OFFICE OF NUCLEAR REACTOR REGULATION
REQUEST FOR ADDITIONAL INFORMATION
REGARDING THE RENEWAL OF
THE ARMED FORCES RADIOBIOLOGY RESEARCH INSTITUTE
TRIGA REACTOR FACILITY
LICENSE NO. R-84; DOCKET NO. 50-170

The U.S. Nuclear Regulatory Commission (NRC) is continuing its review of the Armed Forces Radiobiology Research Institute (AFRRI) license renewal application dated June 24, 2004 (a redacted version of the safety analysis report (SAR) is available on the NRC's public Web site at www.nrc.gov under Agencywide Documents Access and Management System (ADAMS) Accession No. ML041800067), as supplemented. The NRC staff's review used the guidance in NUREG-1537, Part 1, "Guidelines for Preparing and Reviewing Applications for the Licensing of Non-Power Reactors: Format and Content," and supporting information from the American National Standards Institute/American Nuclear Society (ANSI/ANS)-15.1-2007, "The Development of Technical Specifications for Research Reactors." During our review, questions have arisen, for which additional information and clarification is needed. This request for additional information (RAI) identifies the additional information needed to continue our review. Many o

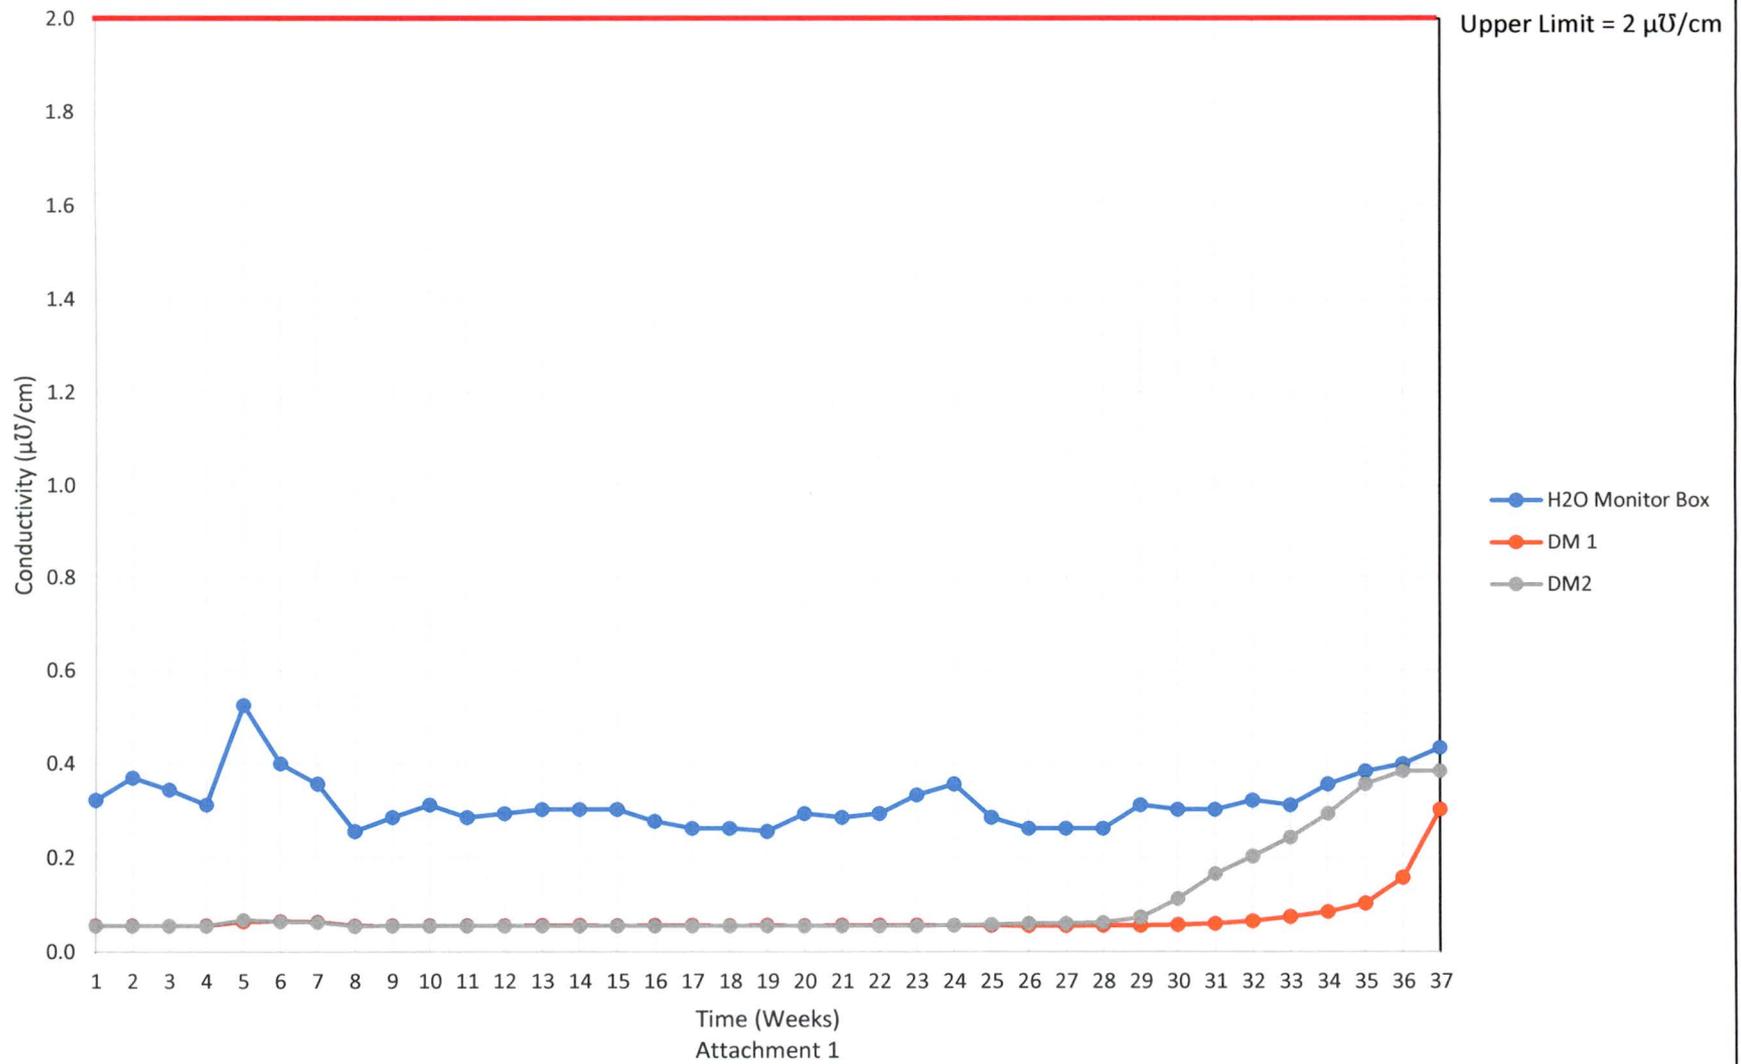
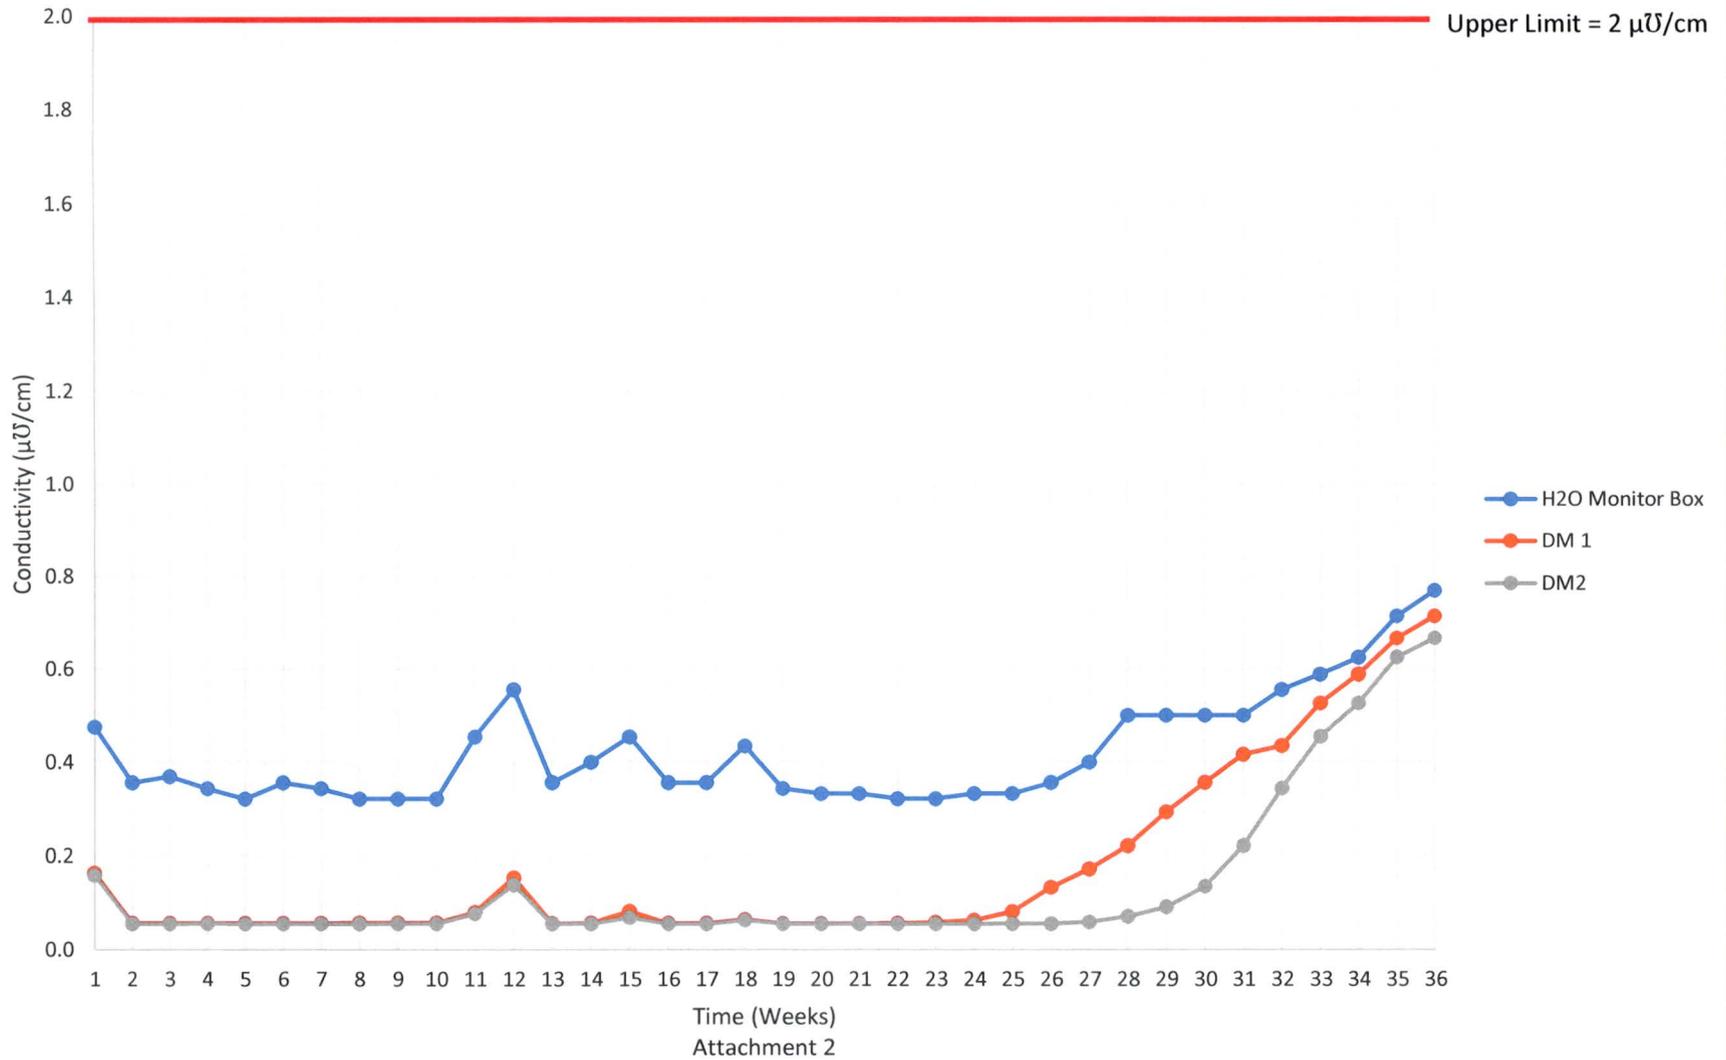
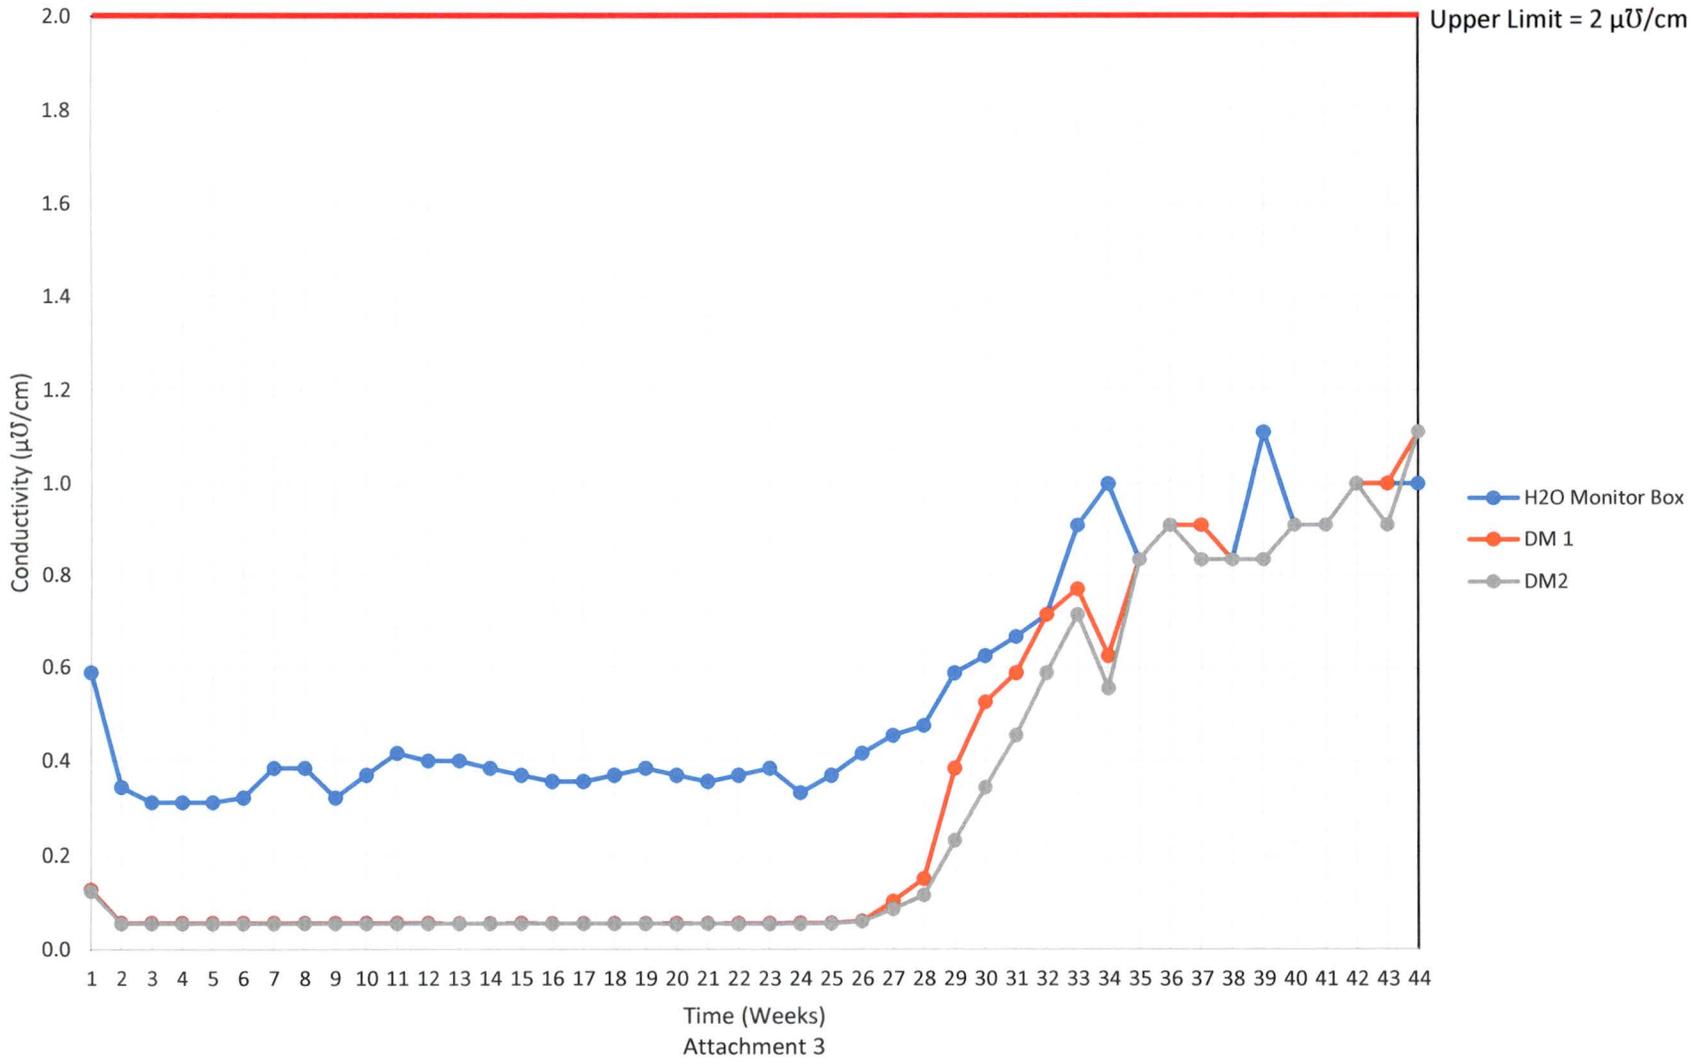
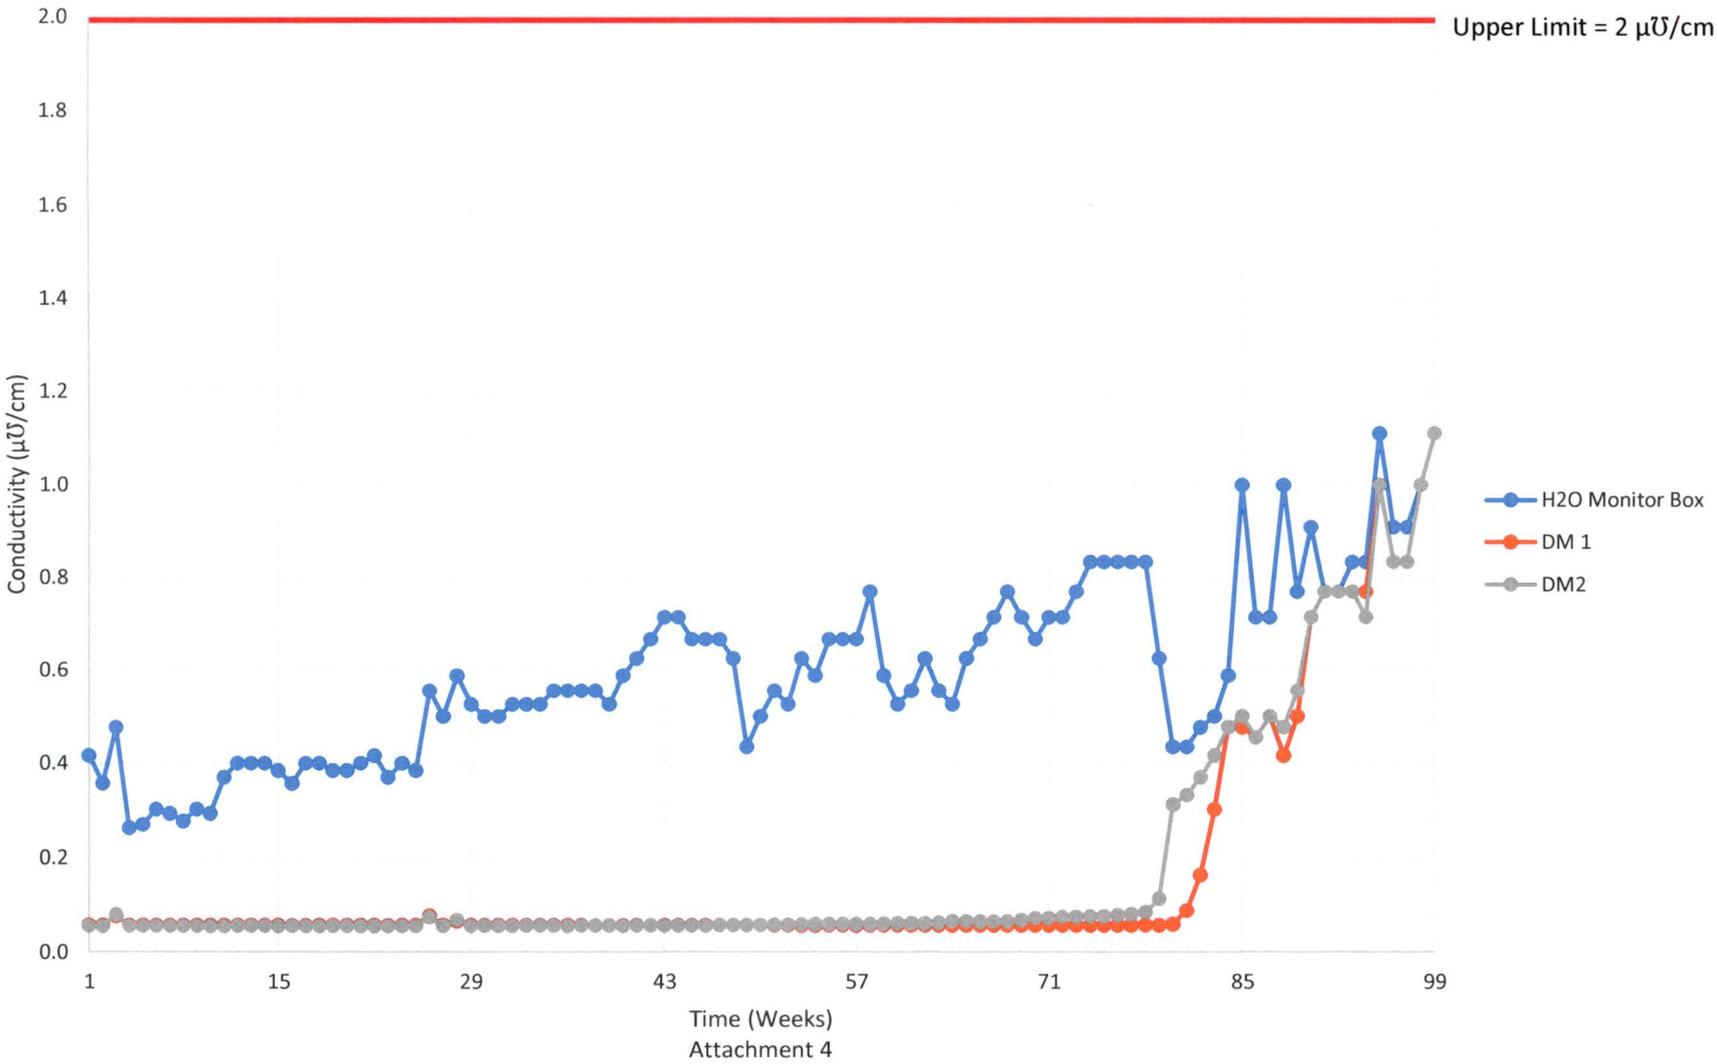
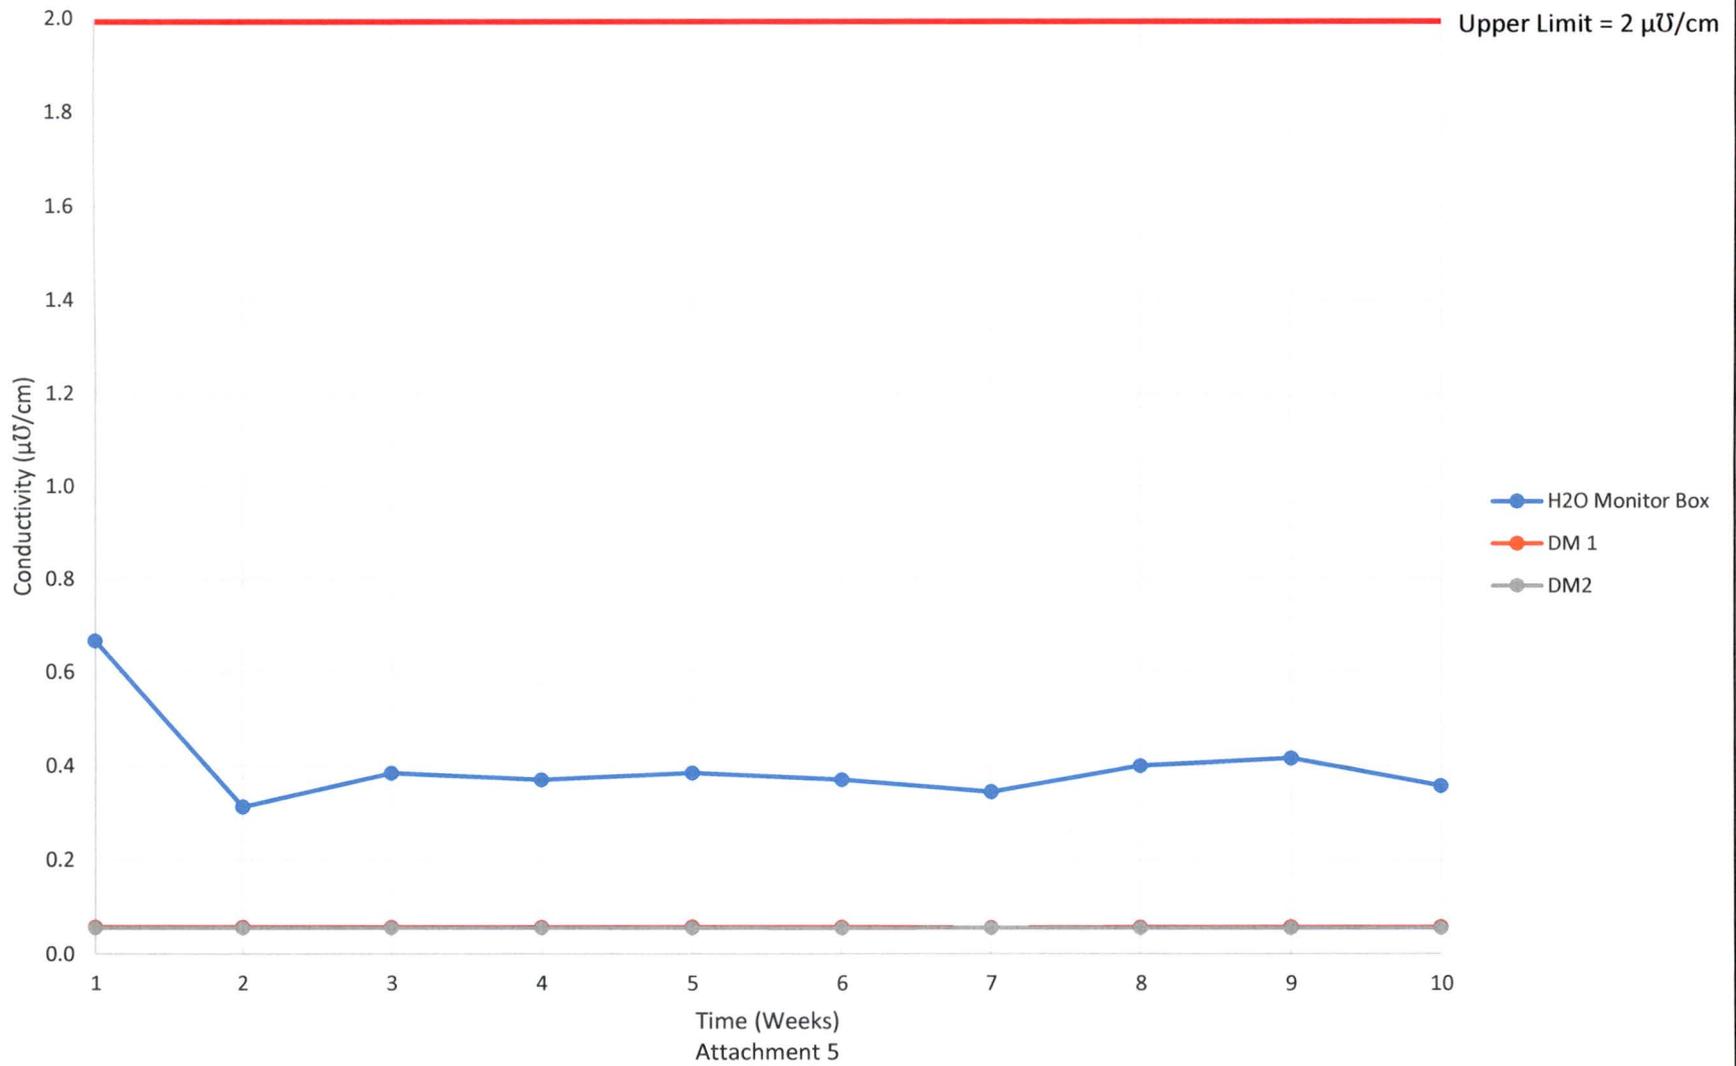
- B. The basis for the proposed TS 3.3 pool temperature limit discusses the protection of the water purification resins. Given that the thermal hydraulic analysis was based on the assumption of a maximum pool temperature of 60 degrees C, and given that reactor operation at temperatures greater than 60 degrees C would be unanalyzed, provide a revision to proposed TS 3.3 that specifies 60 degrees C as the maximum temperature permitted. Provide an appropriate basis for TS 3.3 that considers the results of the thermal hydraulic analysis. (See also RAI 31.D.)

The AFRRR TRIGA core is comprised of stainless steel clad fuel. Corrosion is generally not an issue with SS clad fuel. Furthermore, corrosion is not a flash process, so that monthly measurements will provide reasonable assurance that the resins are operating within normal parameters. Attachments 1-6 show conductivity vs time over the course of 5 years of normal operations. During the sample 5 year period of time, resins were changed out at intervals ranging from 36 to 99 weeks. During this time frame, the conductivity rarely exceeded 50% of the allowed value. Given the proven stability of the AFRRR system, sampling intervals of 90 days should be sufficient to protect the integrity of the system. The proposed sampling interval of monthly would appear to be excessive; however AFRRR will accept monthly

surveillance for conductivity measurements. No change to the proposed TS surveillance is warranted.
